DATE MAILED: 04/19/2005

•		•	C	
	Application No.	Applicant(s)		
Office Action Summary	10/680,732	NGUYEN ET AL.		
	Examiner	Art Unit		
	Cheryl Miller	3738		
The MAILING DATE of this communication appears on the cover sheet with the correspondence address Period for Reply				
A SHORTENED STATUTORY PERIOD FOR REPLY IS SET TO EXPIRE 3 MONTH(S) FROM THE MAILING DATE OF THIS COMMUNICATION. - Extensions of time may be available under the provisions of 37 CFR 1.136(a). In no event, however, may a reply be timely filed after SIX (6) MONTHS from the mailing date of this communication. - If the period for reply specified above is less than thirty (30) days, a reply within the statutory minimum of thirty (30) days will be considered timely. - If NO period for reply is specified above, the maximum statutory period will apply and will expire SIX (6) MONTHS from the mailing date of this communication. - Failure to reply within the set or extended period for reply will, by statute, cause the application to become ABANDONED (35 U.S.C. § 133). Any reply received by the Office later than three months after the mailing date of this communication, even if timely filed, may reduce any earned patent ter

Attachment # 1 (marked up

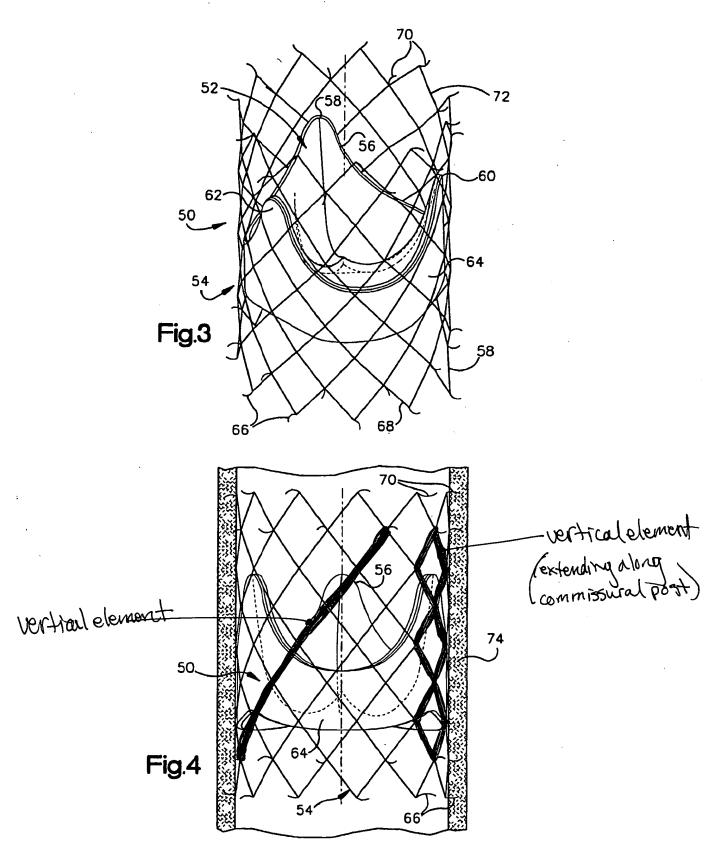
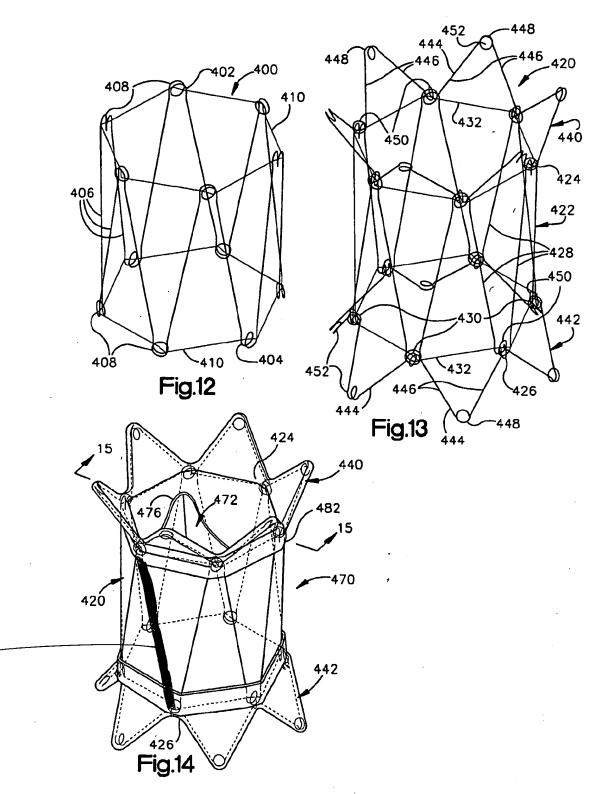
Claims 1-3 and 5-7 are rejected under 35 U.S.C. 102(e) as being anticipated by Gabbay (US 2003/0040792 A1). Gabbay discloses an assembly (fig. 2, 4, 14, 18) comprising a replacement valve (12, 472, 590) having leaflets (22, 24, 26; 480) and a scalloped inflow annulus (inflow annulus is shown to be scalloped in all figures, but most clearly seen in figs. 1, 4, 15, 24) and an expandable anchoring structure (14, 420) having flared rims (see fig. 15, 18, 14, 11, 2) and vertical elements (any element seen in red in attachment 1) extending between the rims. Gabbay discloses the valve (12, 472, 590) to be positioned internal of the anchor structure (see figs). Gabbay discloses the inflow rim of the anchor structure to have one or more rings (see attachment 2) in undulating patterns and the outflow rim to comprise diamond and hexagon structures (fig. 2). Gabbay's elements are configured to coincide with sinus commissural posts of the native valve (see attachment 1).
